MEMO LETTER

CSE FILE #: 20-2

PROJECT NAME: CHANDLER RESIDENCE

From: cseholbrook@gmail.com
Subject: Chandler Residence - CSE Memo Letter for Missing Footing
Date: Oct 22, 2020 at 9:19:36 AM
To: chandlerconst@hotmail.com

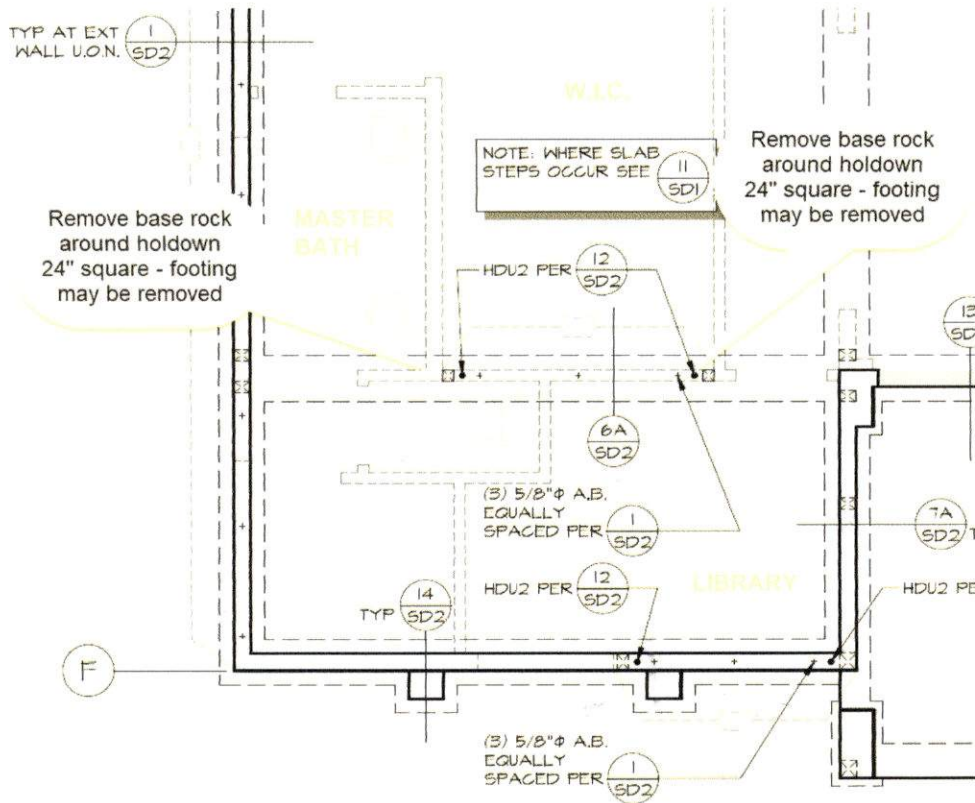
AT GRIDLINE E, THE FOOTING MAY BE OMITTED, BUT A SQUARE PAD NEEDS TO BE PLACED UNDER THE HOLDDOWNS AS NOTED BELOW:
